**Report of the Committee on**

**Health Care Facilities**

Figure 4-3.2.1.10 Typical Level 1 vacuum source.

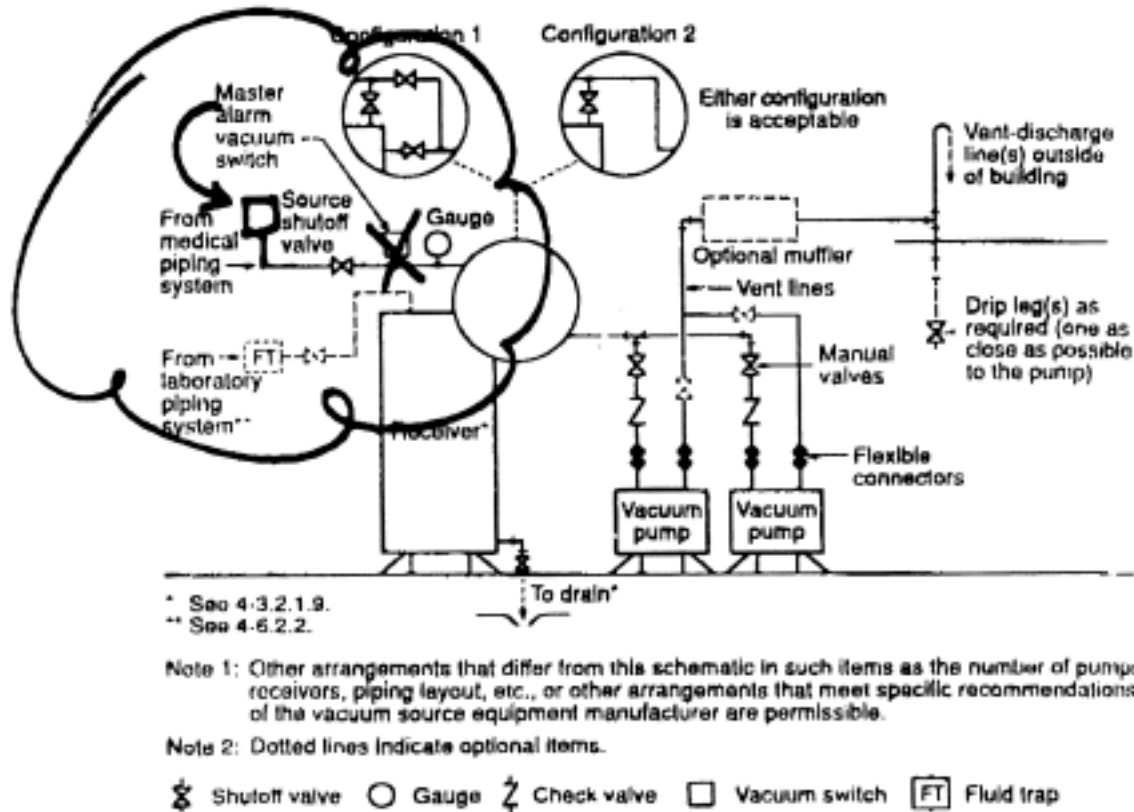
99- 209 - (Figure 4-3.2.1.10): Reject  
**SUBMITTER:** Kurt P. Kubli, M/E Engineering  
**RECOMMENDATION:** Per 4-3.2.2.8(b) Master alarm switch should be located between the source shutoff valve and the medical piping systems.

**SUBSTANTIATION:** None given.

**Figure 8.4.1.3.5.5 Test circuit for measuring chassis leakage current.**

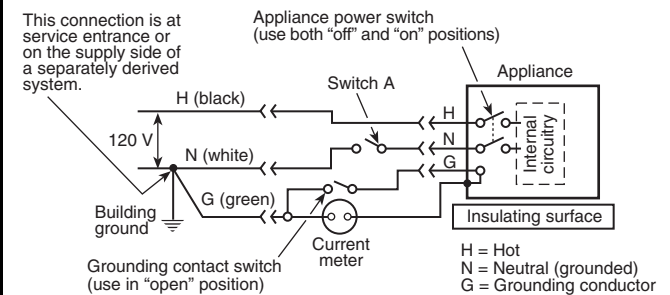
- 8.4.1.3.5.5 7-5.1.3.5.2 Chassis Leakage Test Procedure. Measurements shall be made using the circuit, as illustrated in Figure 8.4.1.3.5.5, with the appliance ground broken in two modes of appliance operation as follows:

(d) Test shall be made with Switch A in Figure 8.4.1.3.5.5 closed.

Figure A-11-4.3

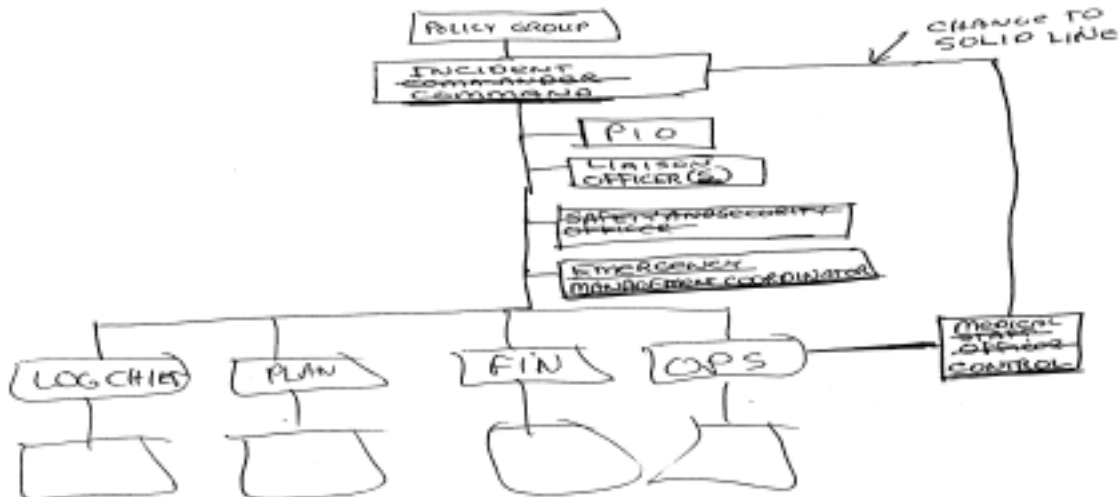
**RECOMMENDATION:** Revise text as follows and change Figure A-11-4.3:

DUE TO THE NATURE OF A HEALTH CARE FACILITY, ONE DEVIATION FROM THE TRADITIONAL ICS IS MADE TO SHOW A LINE OF MEDICAL CONTROL, ABOVE THE ADVISORY POSITION OF THE "MEDICAL STAFF OFFICER".
